Agenda Item # 8

SUB-003556-2025

Creekline-Cypress Subdivision

- Subdivision approval to create two (2) legal lots of record from two (2) metes-and-bounds parcels.

DETAIL SITE PLAN

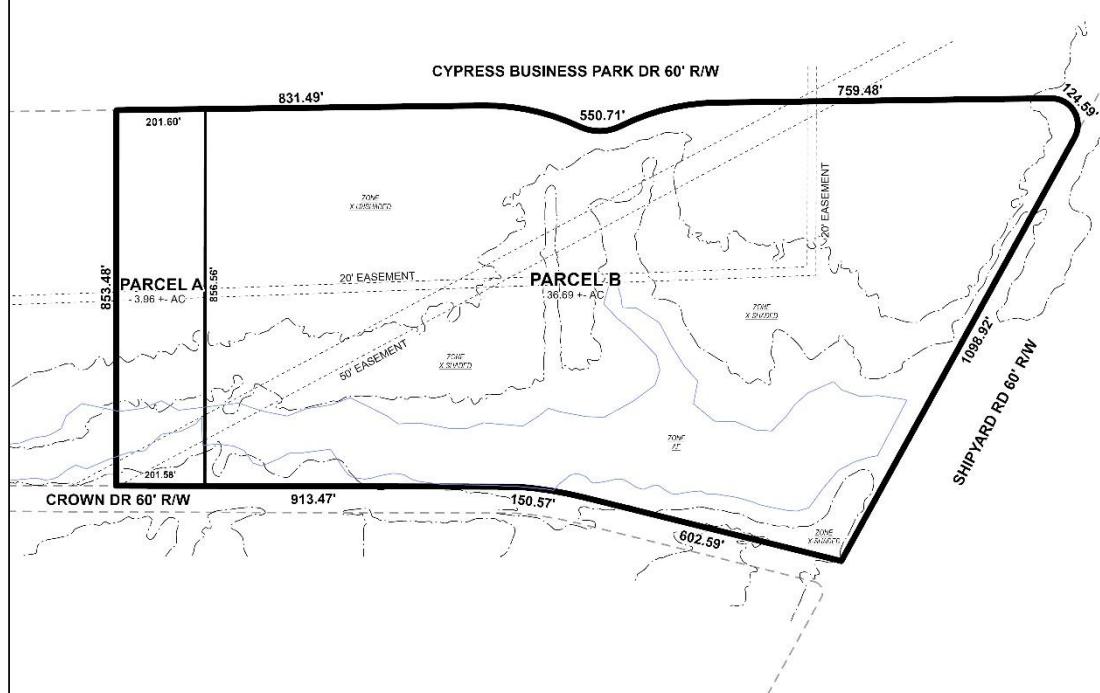
- B. Show and label the POB.
- C. Add legible street names to the vicinity map.
- D. Dedicate the corner radius (25' minimum or as approved by the City Engineer and Traffic Engineer) at the southeast corner of PARCEL B to the City of Mobile and list the amount of dedicated acreage in SF and Acres.

- F. Clearly show and label all flood zones. The information is hard to see when printed at 11"x17".
- G. Show and label the MFFE (Minimum Finished Floor Elevation) on each lot that contains an A, AE, or X (shaded) flood zone designation. BFE = 11.

- H. Provide a drainage easement from the existing drainage that flows from Cypress Business Park Dr. to the major drainageway along the south side of the subdivision; and for the existing major drainageway that runs along the south side of Parcel A and B. The width and location will need to be coordinated with the ENG Dept. (Attn. George Davis) before the FINAL PLAT can be signed.

Proposed “Parcel B” is situated at the intersections of Shipyard Road and Cypress Business Park Drive, and Shipyard Road and Crown Drive. Section 6.B.12. of the Subdivision Regulations requires curb radii of not less than 20 feet, or as otherwise approved by the City Engineer. Section 6.C.6. further requires property lines at street intersections to be arcs with radii of at least 25 feet, or as approved by the City Engineer and the Traffic Engineering Director. The preliminary plat depicts a sufficient corner radius dedication at Shipyard Road and Cypress Business Park Drive; however, the plat should be revised to depict a compliant corner radius at the intersection of Shipyard Road and Crown Drive.

Proposed “Parcel A” exceeds the width-to-depth ratio limitation of Section 6.C.3.; however, similar configurations exist in the surrounding area. Therefore, a waiver of Section 6.C.3. may be appropriate.

While Section 6.C.7. of the Subdivision Regulations discourages lots with multiple street frontages, it allows such lots provided access is limited to one street per block face. Given that the site has historically maintained access from all three (3) street frontages without any apparent adverse impacts on the surrounding neighborhood, a waiver of Section 6.C.7. may be appropriate.

Finally, the plat should be revised to illustrate the required 25-foot front yard setback along all street frontages, in accordance with Article 2, Section 64-2-16.E. of the UDC and Section 6.C.8. of the Subdivision Regulations, adjusted for any required dedication.

1. Retention of the right-of-way widths along Cypress Park Drive, Shipyard Road, and Crown Drive on the Final Plat, as depicted on the preliminary plat;

2. Revision of the Final Plat to depict dedication of a 25-foot corner radius at the intersection of Shipyard Road and Crown Drive, or as otherwise approved by the City Engineer and the Traffic Engineering Director, unless waivers of Sections 6.B.12. and 6.C.6. of the Subdivision Regulations are granted by the Planning Commission;

3. Retention of the lot size labels in both square feet and acres, or the provision of a table on the Final Plat providing the same information, adjusted for any required dedication;

4. Revision of the Final Plat to illustrate the required 25-foot front yard setback along all street frontages, in compliance with Article 2, Section 64-2-16.E. of the UDC and Section 6.C.8. of the Subdivision Regulations, adjusted for any required dedication;
